REMARKS/ARGUMENTS

Amendments to the Drawings:

FIG. 3

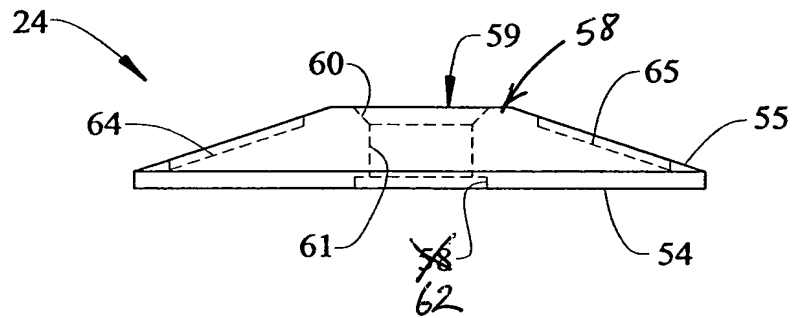
The attached sheets of drawings include changes to Figures 3 and 4. In Figure 3, previously omitted reference numeral 62 has been added and incorrectly labeled element 58 has been correctly labeled. In Figure 4, duplicate reference numeral 86 has been removed.
